EASA	AIRWORTHINESS DIRECTIVE
	AD No.: 2010-0044 [Correction: 25 March 2010] Date: 17 March 2010 Note: This Airworthiness Directive (AD) is issued by EASA, acting in accordance with Regulation (EC) No 216/2008 on behalf of the European Community, its Member States and of the European third countries that participate in the activities of EASA under Article 66 of that Regulation.
This AD is issued in accordance with EC 1702/2003, Part 21A.3B. In accordance with EC 2042/2003 Annex I, Part M.A.301, the continuing airworthiness of an aircraft shall be ensured by accomplishing any applicable ADs. Consequently, no person may operate an aircraft to which an AD applies, except in accordance with the requirements of that AD unless otherwise specified by the Agency [EC 2042/2003 Annex I, Part M.A.303] or agreed with the Authority of the State of Registry [EC 216/2008, Article 14(4) exemption].	
Type Approval Holder's Name : AIRBUS	Type/Model designation(s) : A340-200/-300 aeroplanes

TCDS Number : EASA.A.015	
Foreign AD : Not applicable	
Supersedure : None	
ATA 78	Exhaust – Thrust Reverser Actuation System Doors – Replacement
Manufacturer(s):	Airbus (formerly Airbus Industrie)
Applicability:	A

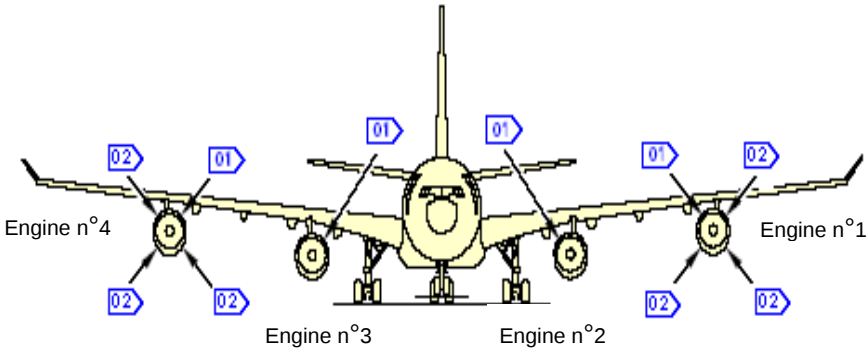
This AD correction is issued to amend the engines numbering in Picture 1 of the "Required action and Compliance Time" section of this AD.
Effective Date:	31 March 2010
Required action(s) and Compliance Time(s):	Required as indicated, unless accomplished previously: (1) No later than 28 February 2011, do the actions specified in paragraph (3) of this AD on the upper inboard thrust reverser pivoting door of each engine, as identified by the label 01 in Picture 1 below. (2) No later than 31 December 2012, do the actions specified in paragraph (3) of this AD on the upper outboard thrust reverser pivoting doors of engines n°1 and n°4, and lower thrust reverser pivoting doors (inboard and outboard) of engines n°1 and n°4 as identified by the label 02 in Picture 1 below. (3) Replace the primary lock in accordance with the instructions defined in Airbus Service Bulletin (SB) A340-78-4037, and Remove the installed shim and replace the actuator in accordance with the instructions defined in Airbus SB A340-78-4038.  Picture 1
